RE: City of Decatur WWTP Inspection
AFIN: 04-00052 Permit No.: AR0022292

OFFICE OF WATER QUALITY INSPECTION REPORT

RE: City of Decatur WWTP Collection System Inspection
AFIN: 04-00052 Permit No.: AR0022292

Grant Lift Station

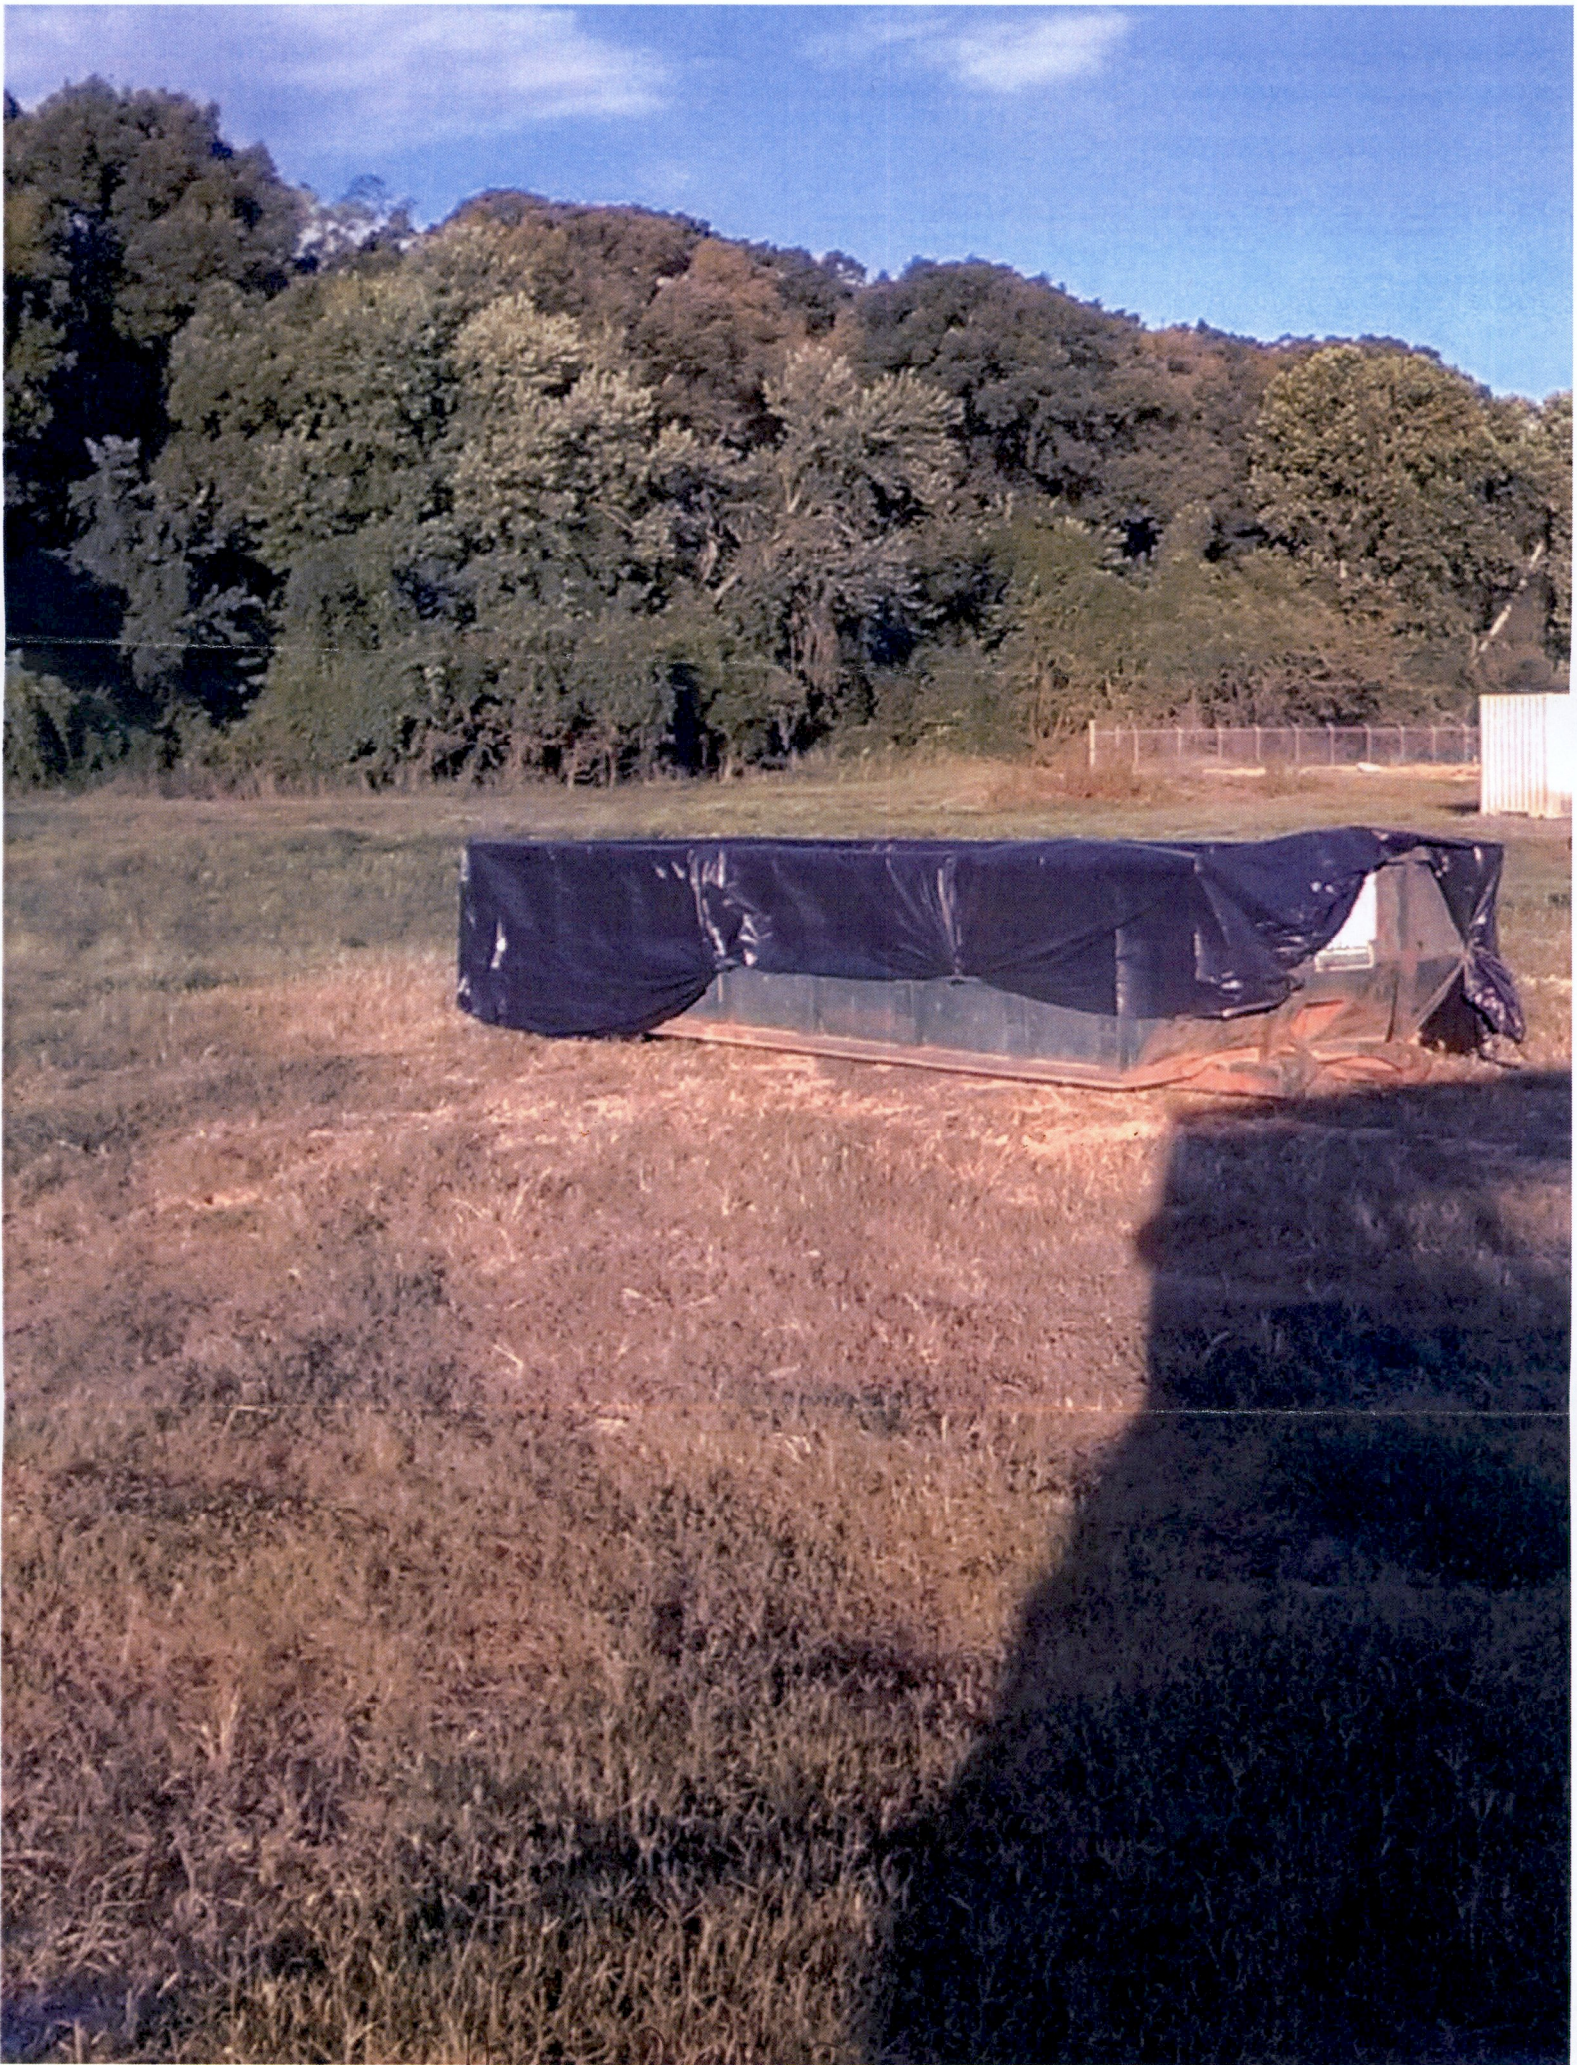
Part III, Section B.1 of the permit: Your response states that you will be replacing a pump in the lift station to increase mixing, continuing to use the aerator, and begin using a degreaser to address the excess grease and solid wastes accumulating in the lift station. Please state if the pump has been replaced. Please submit photographs showing the excess grease and solid waste have been removed.

The second letter has to do with debris on the lift station, although there is always some debris on a lift station surface, we have got one of the two pumps replaced with a Meyers grinder pump that has come highly recommended. It shares the duty with one of the previous pumps and has made a difference. I do not want to pull the old pump until it gives us trouble. But do plan on replacing it with the updated grinder when it does give us problems. Picture is included with current condition.
